1. **Title of Submission: Veterans Memorial at 725 Hopmeadow Street and Library Driveway**
2. **Date of submission: April 24, 2014**
3. **Date of Board Meeting: April 28, 2014**
4. **Individual or Entity making the submission: Terri-Ann Hahn, LADA, 104 West Street Simsbury, CT**
5. **Action requested of the Board of Selectmen (Acceptance of gift, creation of reserve, approval of contract, information only, etc. Be as specific as possible with respect to the desired action of the Board.):**
The Board of Selectmen is requested to:

RE: Simsbury Veterans Memorial

SIMSBURY VETERANS MEMORIAL

Re: Veterans Memorial

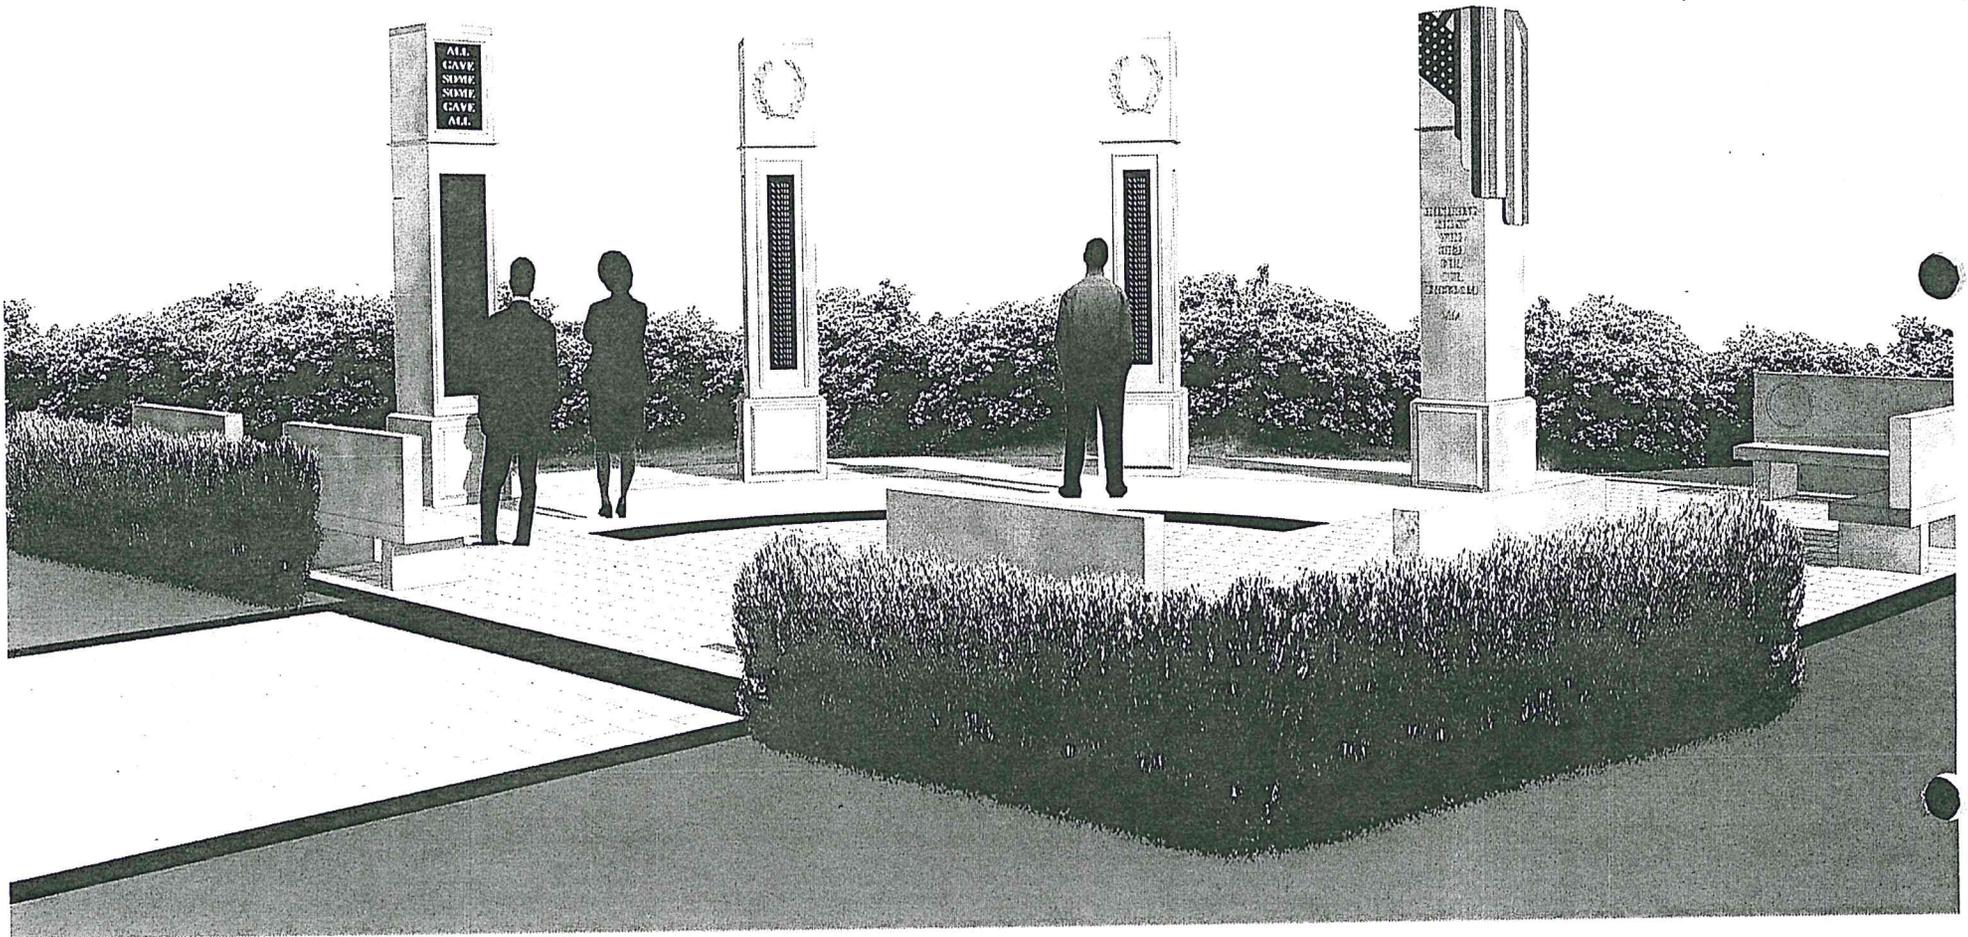
1. The creation of the pond which was part of the original library design, and also part of the Town Center charrette process should be considered as an integral part of any final design for the memorial. This may mean reconsideration of how the memorial will be perceived with the pond in the rear as opposed to a stand of trees. The visibility thorough the memorial with the pond in the background will make a substantial difference as to how the entire setting is perceived. It was felt the inclusion (acknowledgement) of the pond in the design at this time would make for a more integrated design and product.

2. The finish of the back side of the memorial should be considered as it will likely be visible from a number of locations in addition to the Hopmeadow frontage.

3. The proposed flagpole should be increased in height from 25 feet to 40 feet.
4. Coordination of the memorial construction along with the pond construction should be undertaken at this time so that the overall design of the rear walkway of the memorial can be more naturally integrated into the overall design of both elements. The rear portion of the walkway should be blended more smoothly into to overall footprint.

5. All the DRB members felt the use of the pillars should be reconsidered and reviewed in the context of the location and the fact that a more rural contemplative setting. Possibly the benches overlooking the pond would be a larger part of the design than is currently the case would be helpful to the overall design.

6. The required minimum setback per the Town Center Code is 10 feet from the ROW lane.
7. The memorial should be set back further from the corner of the library driveway so as to give the entire memorial more "breathing room" and a greater feeling of open ness around it. Currently the plaza has a crowded feeling as pinched between busy Hopmeadow Street and a busy Library driveway. This may mean working with the Town Engineer to arrive at a better concept for the interface of the rear of the memorial and the pond edge and grading.

1. We have prepared a number of pond layouts and discussed them with Rich. We have attached the most likely scenario that shows the proposed project and how the grading for the two elements would blend to allow a path down to the pond water elevation. The project includes a planted slope which would be expanded when the pond is built.
2. The columns are now visible from all four sides and the plaza extends so you can walk around the columns.
3. The proposed flagpole height will be 35'.

4. We have included a possible pond layout as attached. The proposed project does not in any way interfere with the pond and we are showing how a walkway could be extended below the memorial down to the waters edge. The proposed memorial does not conflict or limit the pond in any way.
5. The proposed design reflects the aesthetics preferred by the veterans and we believe it will be a significant asset to the streetscape on Hopmeadow Street.
6. All vertical elements meet the 10' setback requirements including the flagpole.
7. The design has changed so that there is now a wide walkway through grass to the plaza.
